Office Action Summary

10/553,295

RAATIKAINEN, JUHA

DETAILED ACTION

attachment #1

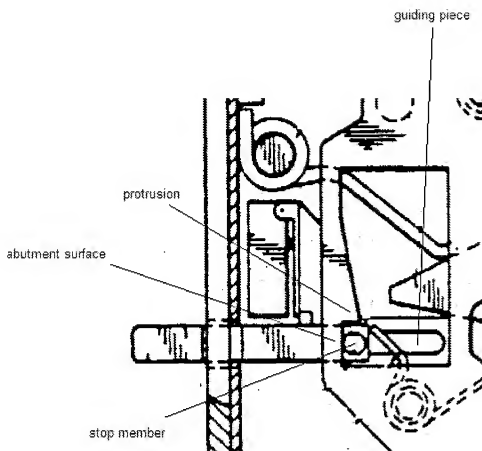
As to claim 21, Kärkkäinen illustrates that the auxiliary bolt is provided with a guiding piece that defines the freedom of movement of the stop member and is arranged to guide the movement of the auxiliary bolt (attachment #1).

As to claims 24, 27, 30 and 31, Kärkkäinen illustrates that the guide element (11) has an abutment surface that is engaged by the stop member when the stop member prevents the guide element moving to the position providing deadlocking of the latch bolt and the guide element has a protrusion that prevents the stop member moving clear of said abutment surface while the latch bolt and the auxiliary bolt are in their protruding positions (attachment #1).
